CITY OF ALBUQUERQUE

Re: Duplex for Ahmet Tiryaki
12016 Copper Ave. NE
Traffic Circulation Layout
Architect's Stamp: 9/4/2022 (K22D065)

The revised TCL received 9/5/2022 with comments addressed is approved for building permit by Transportation.

RE: **DUPLEX PROJECT FOR TIRYAKI**, 12,016 COPPER AVE NE, ALBUQUERQUE, NEW MEXICO,
TRAFFIC CIRCULATION LAYOUT (K22-D065)- ARCHITECT'S STAMP DATED 7/7/2022 - RESPONSE
TO TRAFFIC CIRCULATION COMMENTS DATED 8/10/22.

DRAWING TITLE:
TRAFFIC CIRCULATION LAYOUT

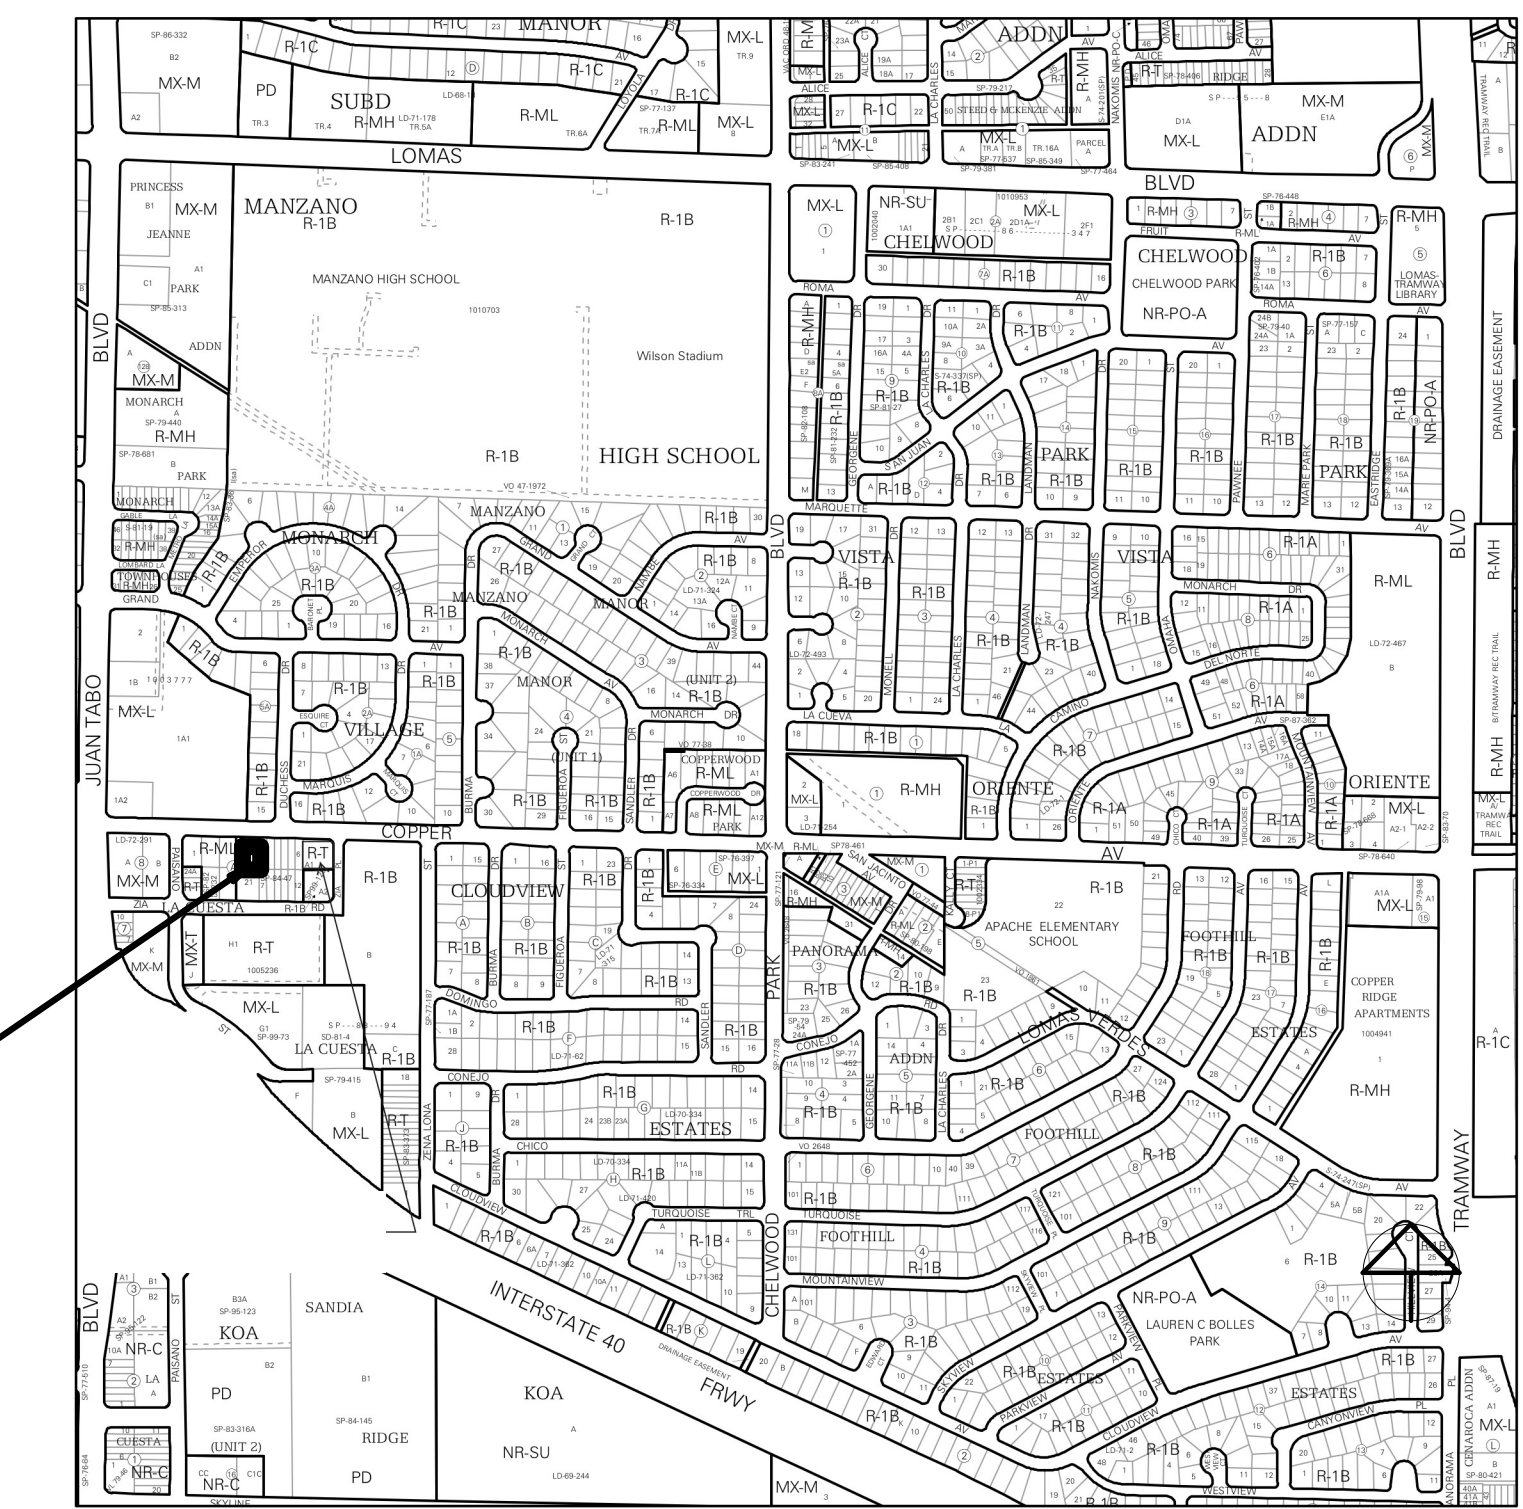
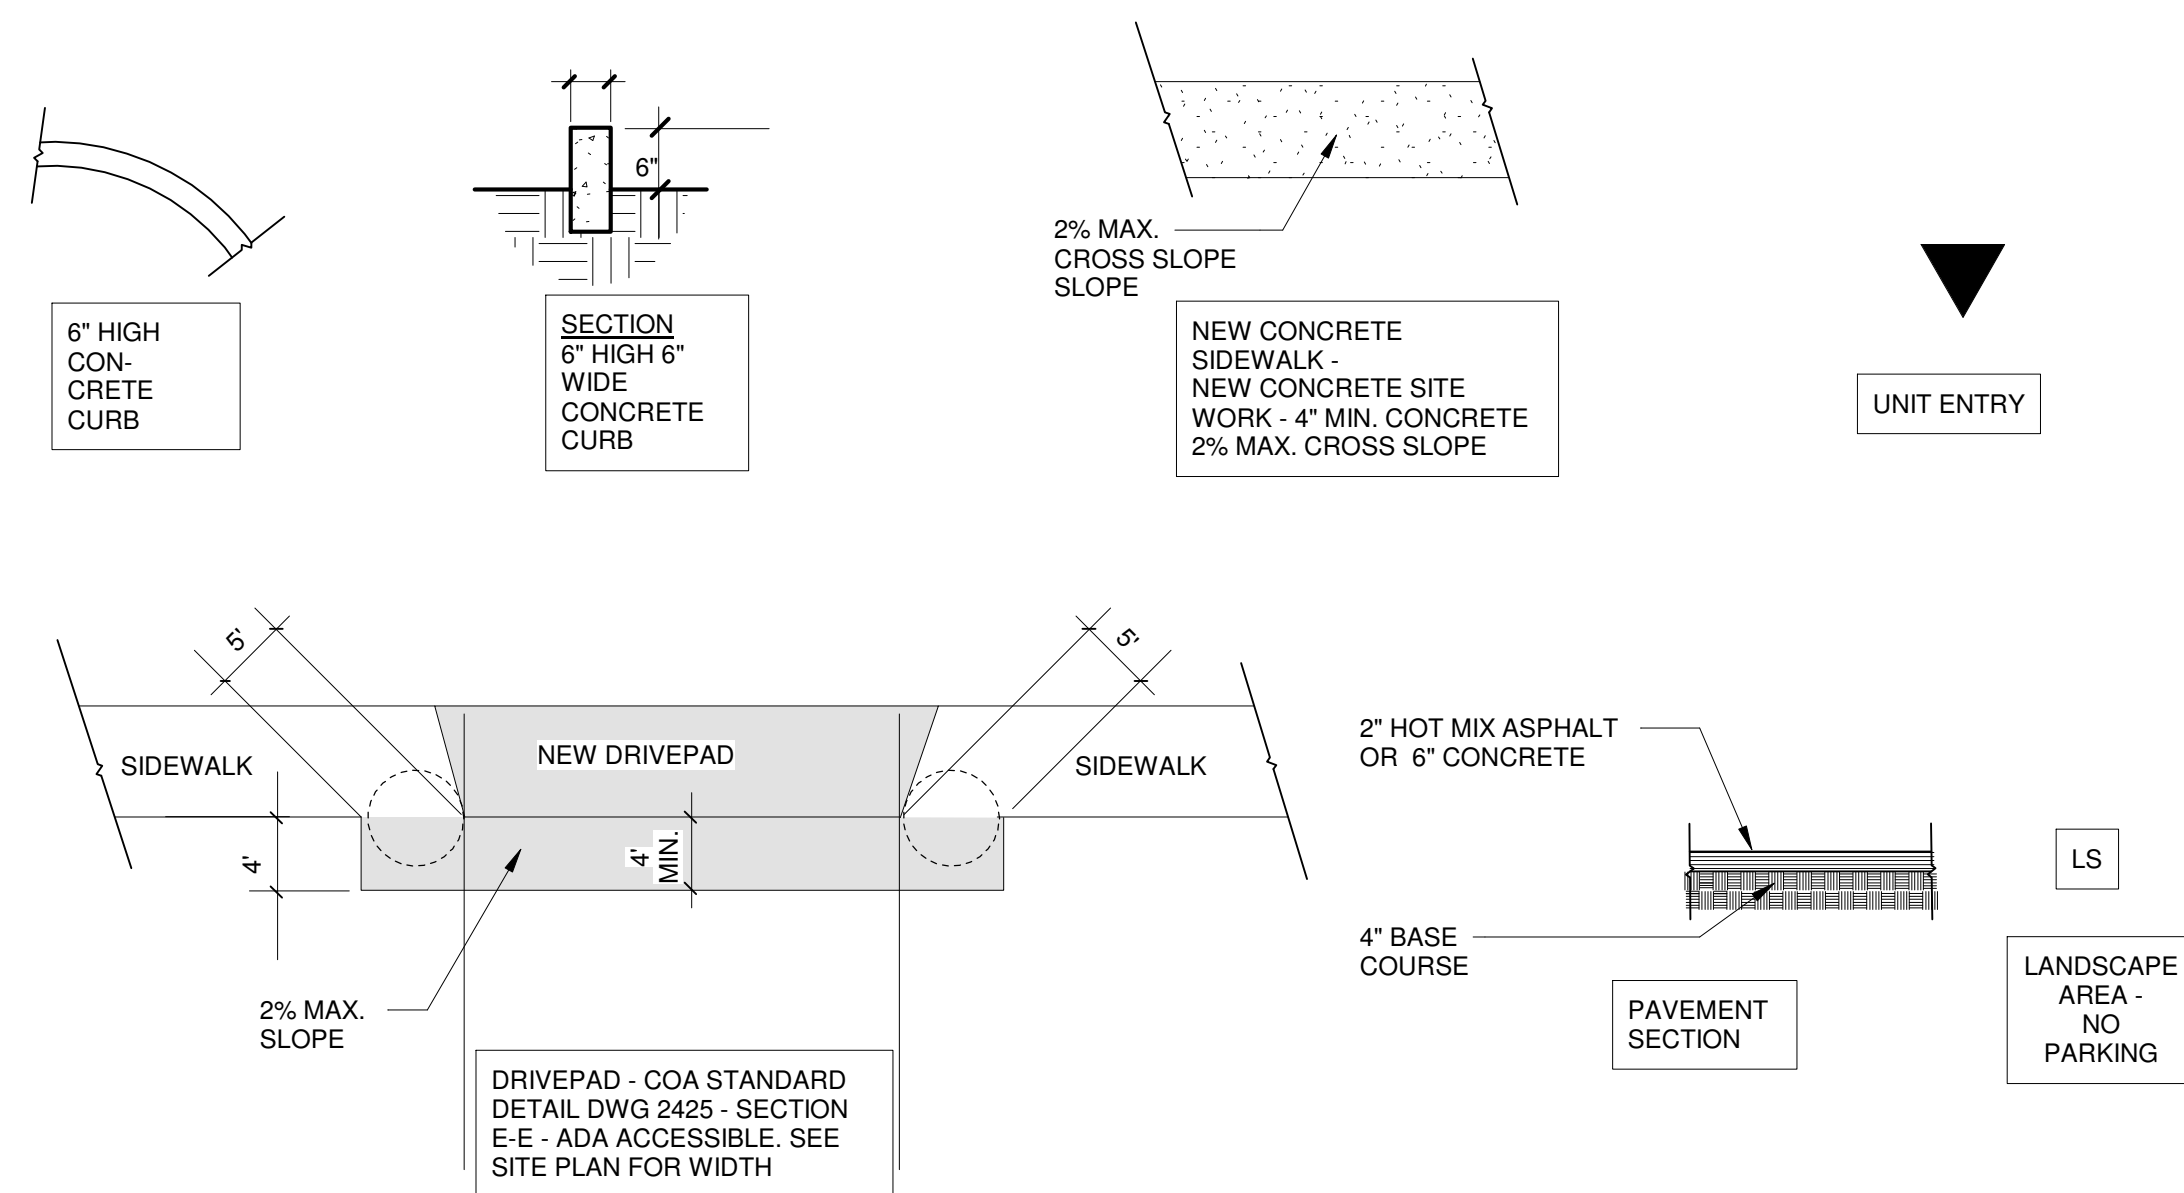
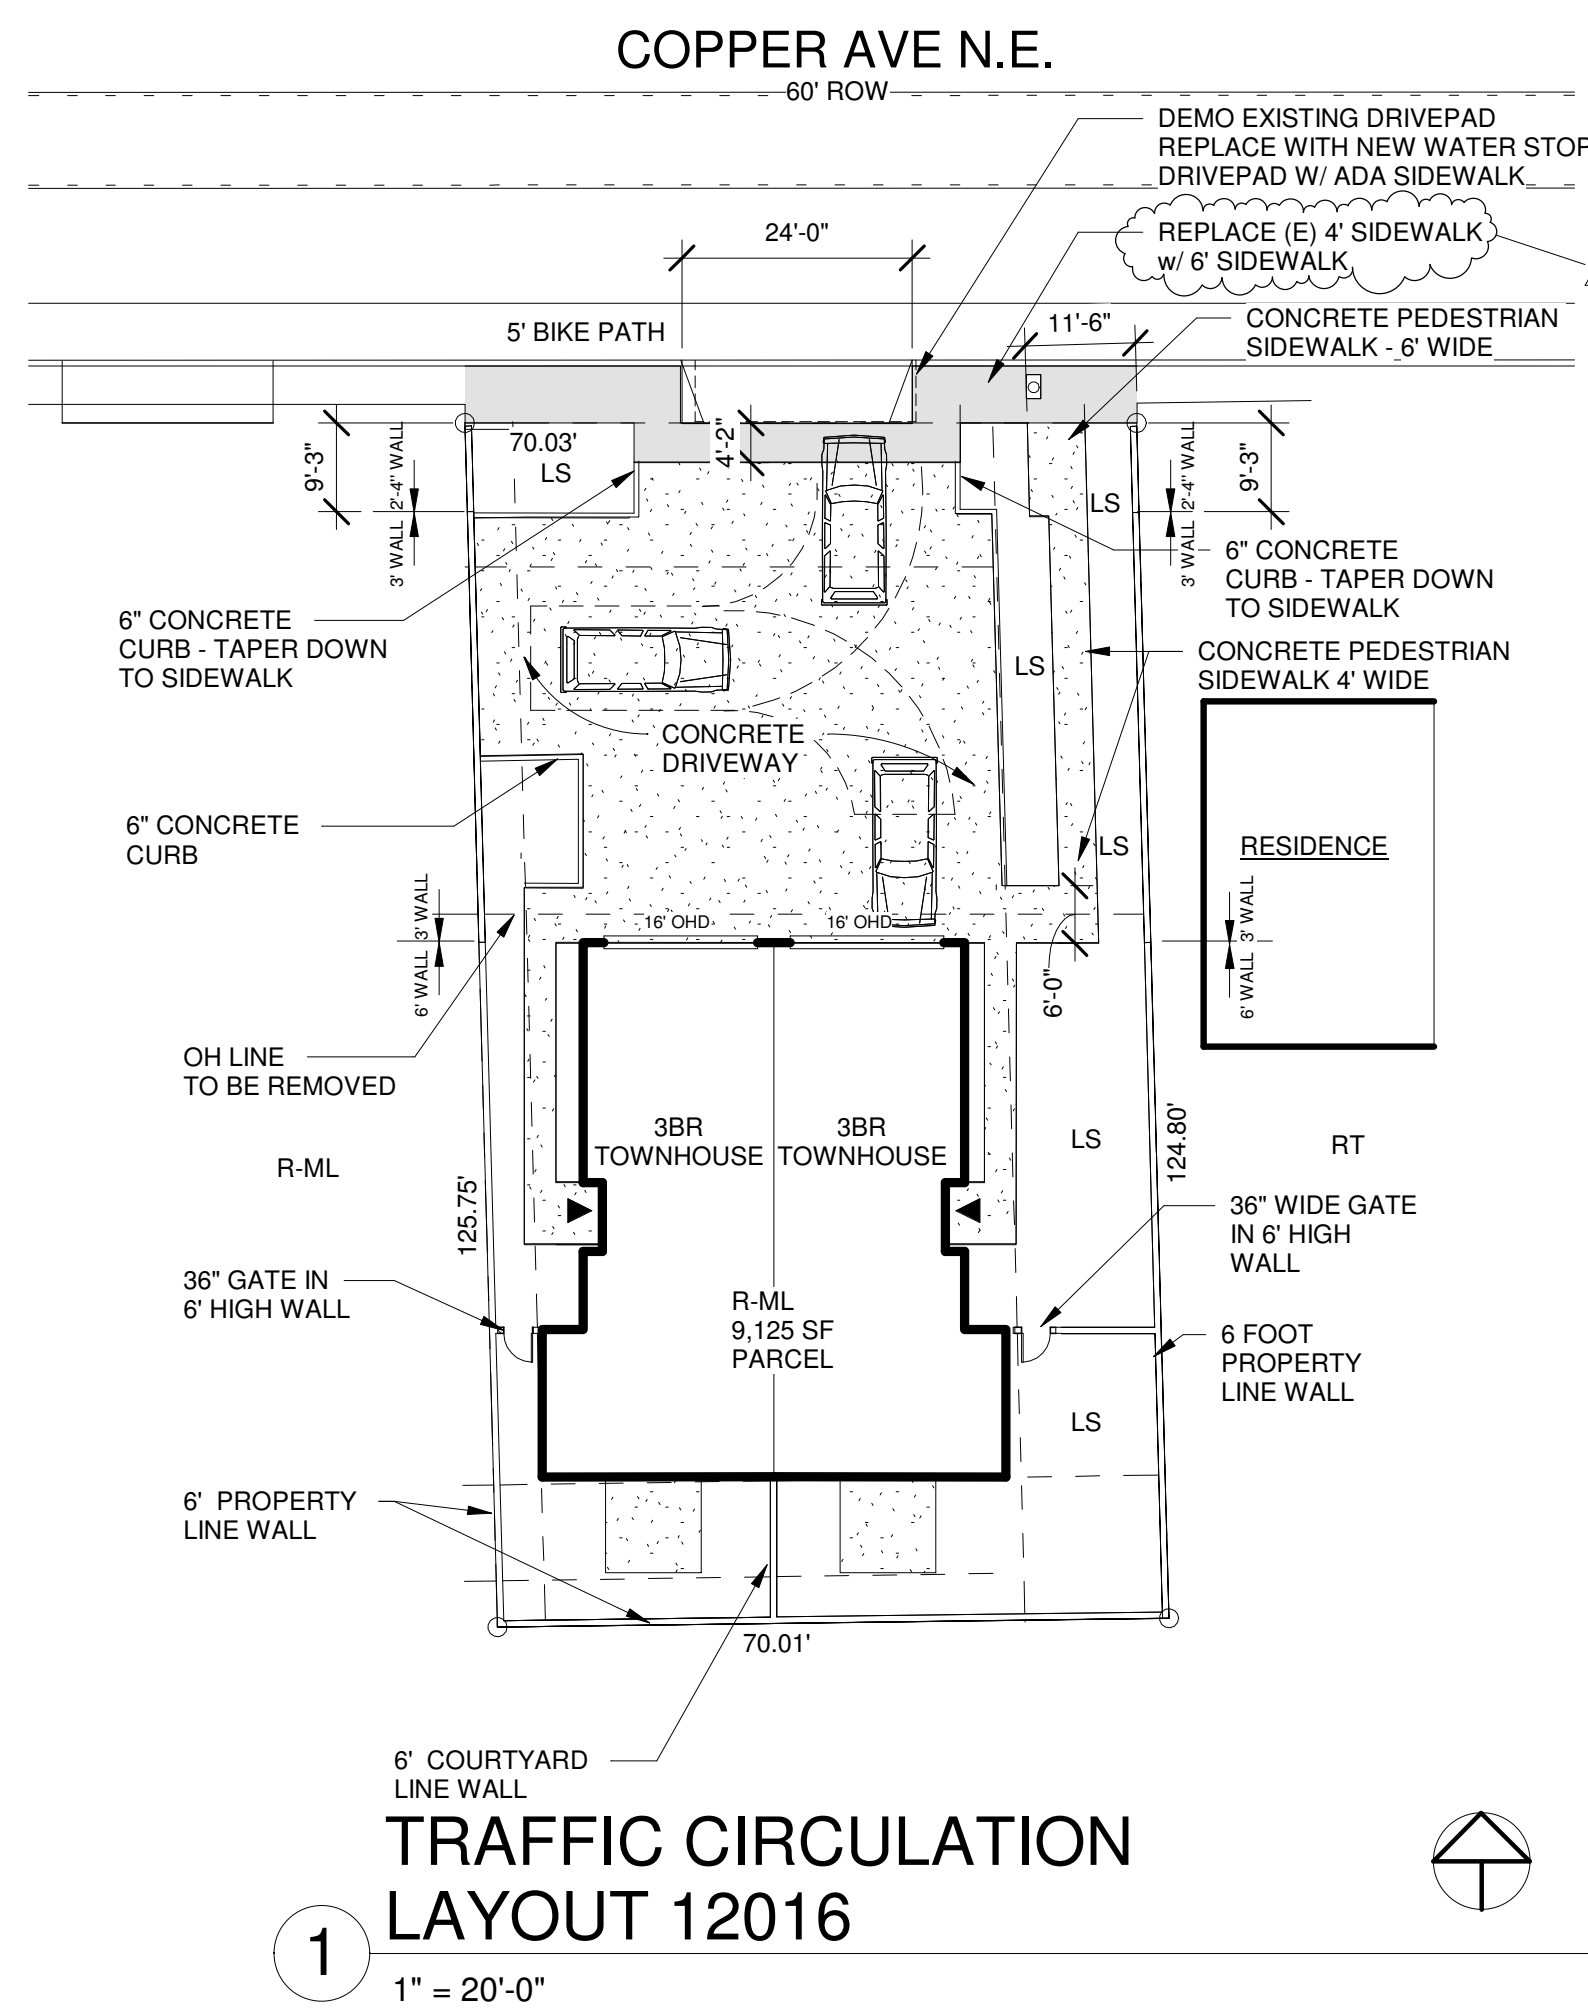
**CONDITION OF C.O. (FINAL) APPROVAL:
SIDEWALK EASEMENT FOR 24'
DRIVEPAD SHALL BE APPROVED,
ACCEPTED AND IN PLACE. (NSF)**

**TRAFFIC CIRCULATION
LAYOUT APPROVED**
